MODIFICATION REQUEST:
Residential and Child Care Centre
Development
14-18 Boondah Road Warriewood
MP09_0162 MOD 3

Director-General's
Environmental Assessment Report
Section 75W of the
Environmental Planning and Assessment Act 1979

December 2012

Figure 2: Proposed building footprints superimposed over the approved footprints of the Stage 2 development

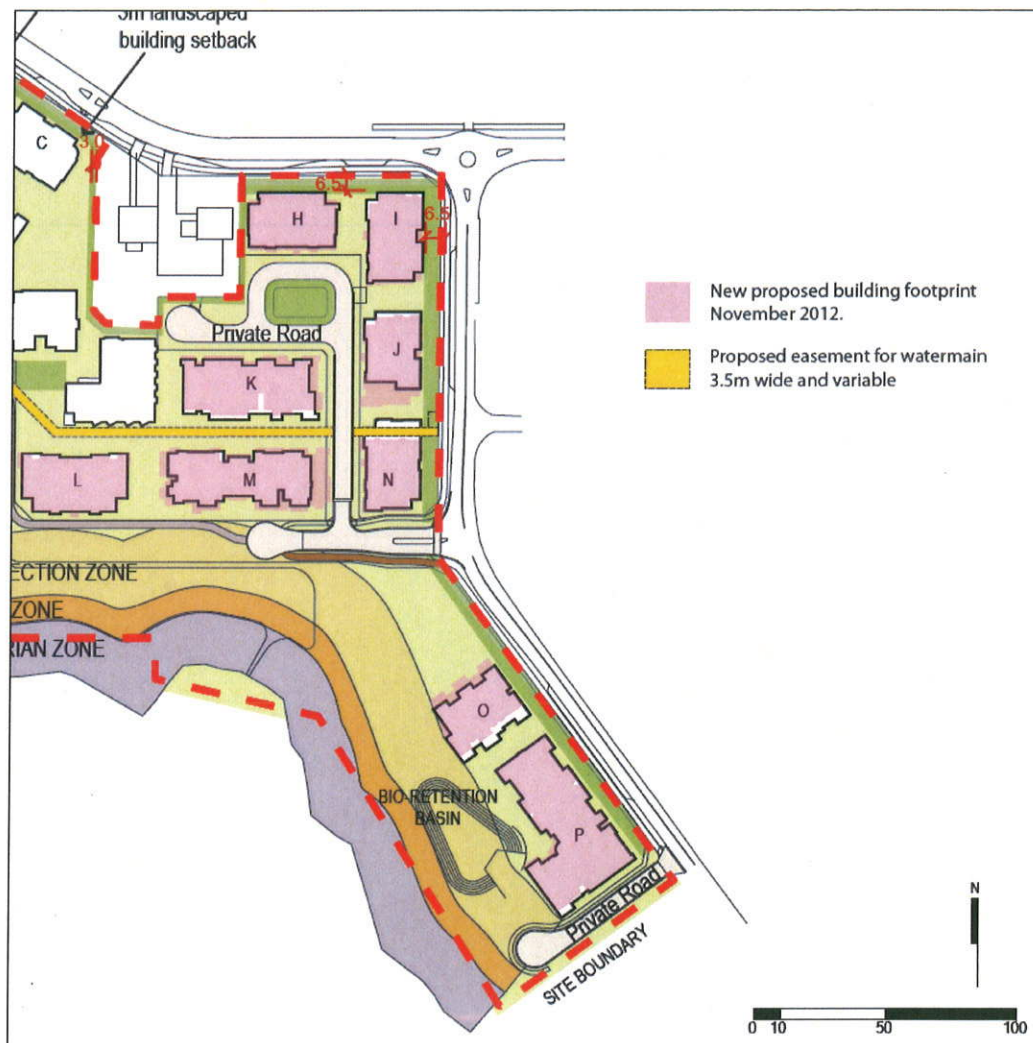
Figure 2 shows the location of the Sydney Water main in relation to the approved and proposed building footprints for Stage 2 of the development. In this regard, the Department makes the following observations:

- it is apparent that the approved footprint of Building N conflicts with the easement for the Sydney Water main;
- setbacks from streets (Macpherson Street and Boondah Road) remain unchanged from the current approval at 6.5m; and
- the impact resulting from an increase in combined footprint area of the buildings is negligible.

The subject proposal does not seek to alter these requirements. Based on the minor nature of the adjustments of the footprints and the maintenance of existing requirements of the Concept Plan relating to dwelling yield and deep soil planting, the Department raises no issue with the proposed adjustments to the building footprints.

Figure 3: Proposed garbage storage building and at-grade car park spaces

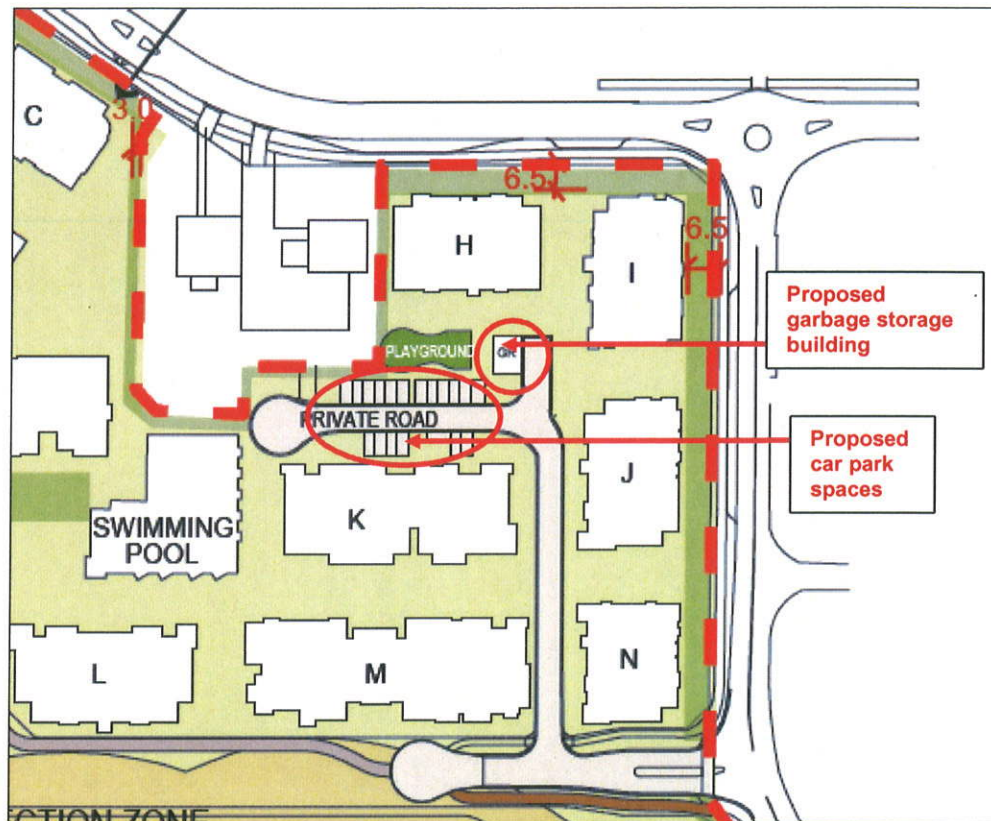
Council raises no objection to the proposal subject to the deep soil planting area not falling below 50%. Council noted this requirement is in response to the addition of a new garbage storage building on the site. The new building is located between the children's playground and the proposed loading zone and is identified in **Figure 3**.

While the proposal will result in a reduction in the provision of deep soil planting area (reduced from 56.13% to 53.86%), the proposed provision is still above the minimum requirement of 50%. The proposed figure is verified in a revised plan identifying the provision of deep soil planting areas.

As the proposal retains a deep soil planting area above Council's minimum requirement of 50%, the Department raises no issue to this aspect of the proposal.

Figure 4: Approved and proposed internal road design

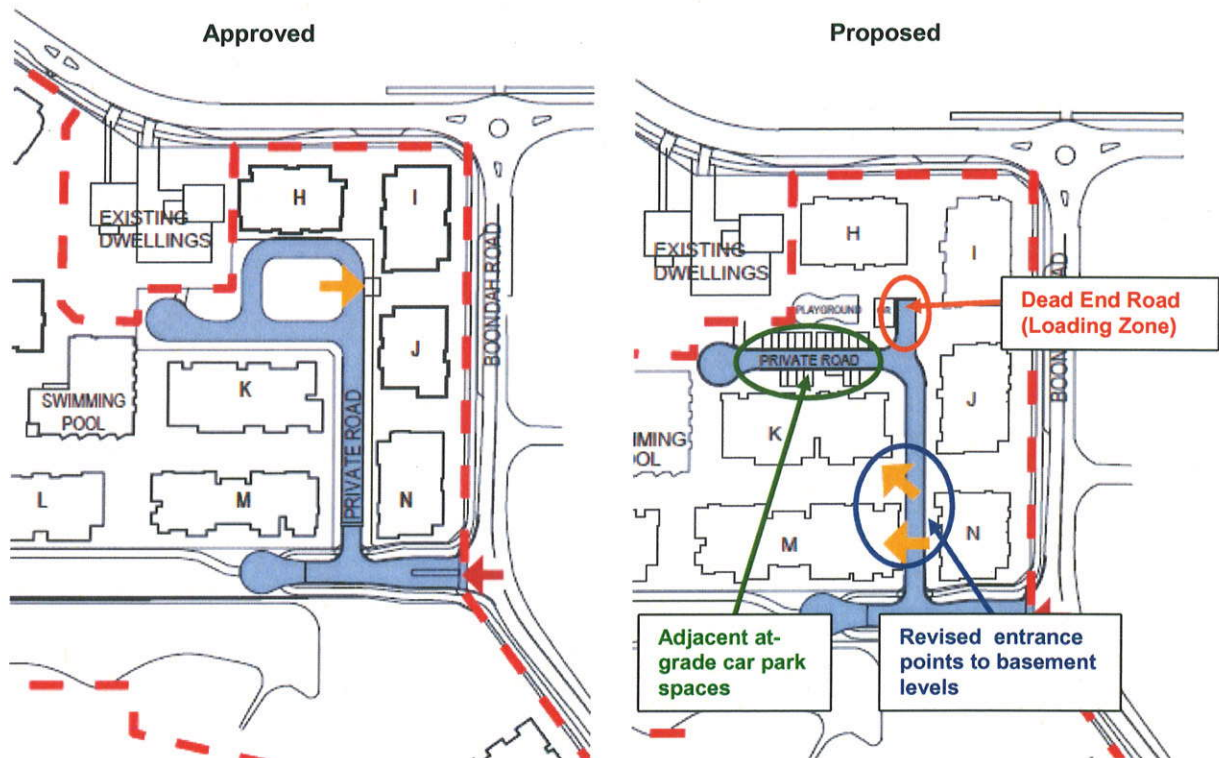
Council raises no objection to the proposal subject to:

- the loading facility being signposted as a loading zone; and
- sufficient turning area being provided adjacent to the garbage storage building for garbage vehicles such that circulation conflicts do not arise with proposed entrances to basement car parking levels or adjoining parking areas.

The Department notes Council's point in relation to the need for sufficient turning area for the loading zone and agrees that any vehicle manoeuvring associated with this area should not conflict with the entrances to the basement parking levels and the at grade visitor car parking.

The submitted plans indicate that the nearest basement entry/exit point is located over approximately 40 metres from the loading area. As such, the Department is satisfied that there will be no circulation conflict between the use of this area and the basement entry/exit points.

The submitted plans indicate that the nearest at-grade visitor car parking spaces are located 10-15 metres to the west of the loading area. The proponent has submitted swept path diagrams demonstrating that trucks will be able to enter and exit the loading area with a single reversing movement into the loading area without entering the parking area. The Department notes that whilst this is nearby the at-grade visitor parking area, no service vehicles would need to use the parking area to access the loading area. As such the Department is satisfied that there will be no conflicts with vehicles also manoeuvring into and out of the at-grade car parking spaces.
